E/ECE/324
E/ECE/TRANS/505 } Rev.1/Add.22/Rev.1/Amend.1

Addendum 22: Regulation No. 23

Revision 1 - Amendment 1

UNIFORM PROVISIONS CONCERNING THE APPROVAL OF REVERSING LAMPS FOR POWER-DRIVEN VEHICLES AND THEIR TRAILERS

Annex 2, Model A of the approval mark and the caption below the figure, amend to read:

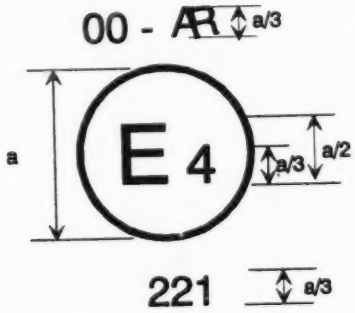
The device bearing ...., as the case may be. The arrow indicates the side on which the required photometric specifications are met up to an angle of 45° H.

a = 8 mm min. "
